UNITED STATES PATENT AND TRADEMARK OFFICE

10/582,809

Mitsuhiro Mori

DETAILED ACTION

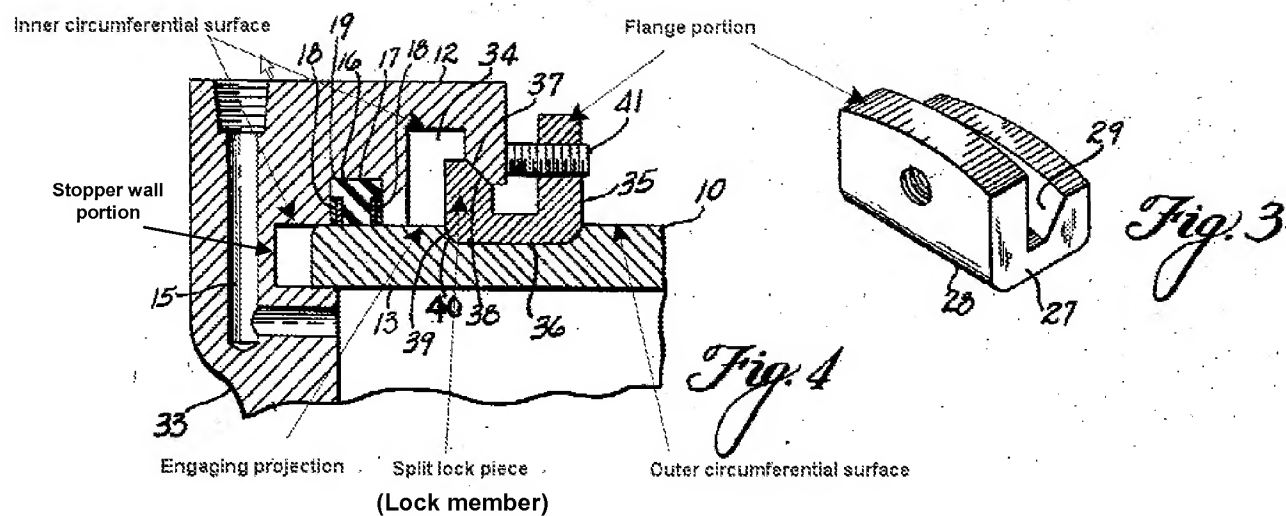
Due to the confusing number of elements in this application, an Examiner's Appendix (EA) has been provided to aid in the understanding of the rejections below. The Appendix includes enlarged and annotated drawings from the primary reference, Woodling (US 2,376,566), as well as a table correlating the claimed elements in the application with the corresponding elements in Woodling. It is intended that these supplements will be helpful references.

As to claim 1, Woodling teaches a pipe joint construction comprising an elastic seal member (17) for hermetically sealing between an inner circumferential surface (annotated Fig. 4, Examiner's Appendix [EA]) of a receiving pipe section (33) and an outer circumferential surface (Fig. 4, EA) of an inserted pipe section (10) inserted into and connected to the receiving pipe section (33) in a pipe axis direction (left-right, Fig. 4),

and a lock member (left-hand radially extending portion of U-shaped member 35; Fig. 4, EA) provided interior to the inner circumferential surface (at top of groove 34) of the receiving pipe section (33) adjacent a receiving opening thereof (Fig. 2, inner perimeter of outer pipe) for preventing separating movement of the pipe sections by contacting an engaging projection (Fig. 4, EA) protruding from the outer circumferential surface of the inserted pipe section (where outer surface of 10 protrudes above the groove 36) in the pipe axis direction,

wherein the construction further comprises an attachment/detachment control device (combination of elements 35) for attaching and detaching the lock member (combination of split lock pieces, Fig. 4, EA) to/from the receiving pipe section (33) by rotating the lock member (each split lock piece individually) about the pipe axis direction relative to the receiving pipe section (33) and by moving, in the pipe axis direction, the lock member placed in a specific attachment/detachment operating position

(when element 35/27 is aligned with 30 in Fig. 2) in a passage of rotation (34) (also, see p. 2, left column/line 70 through right column/line 10).

As to claim 2, Woodling teaches the pipe joint construction as above for claim 1, further comprising a stopper wall portion (annotated Fig. 4, EA) formed in the inner circumferential surface of the receiving pipe section (33) at a portion close to the receiving opening from a seal mounting groove (19) for receiving the elastic seal member (17) to contact an engaging projection (Fig. 4, EA) protruding from the outer circumferential surface (the groove of 10 at 36) of the inserted pipe section in the pipe axis direction, thereby to limit a maximum contracting position between the pipe sections (the stopper wall formed in the end cap of 33 limits the axial movement of 10).
